## Savina Technical Service Bulletin # 3

**Re:** Improvement of EMC

**Date:** December 13, 2001

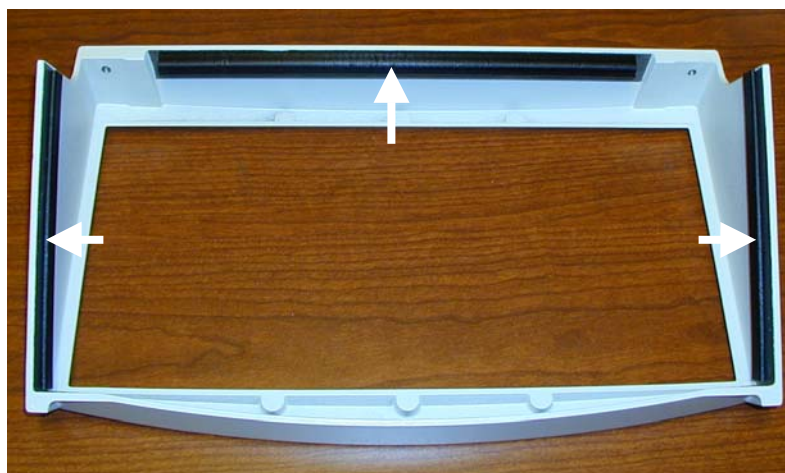
**Reason:** Dräger Medical has released a modification to the Savina Housing P/N 8414280 to improve EMC to 20V/m.

**Additional Info 1:** The new version of the front panel frame has 3 EMC gaskets glued on unpainted areas.

**Ordering Info:** Front panel frame P/N 8414279  
Note: For this action this part comes with 3 EMC gaskets P/N 8414722 assembled.
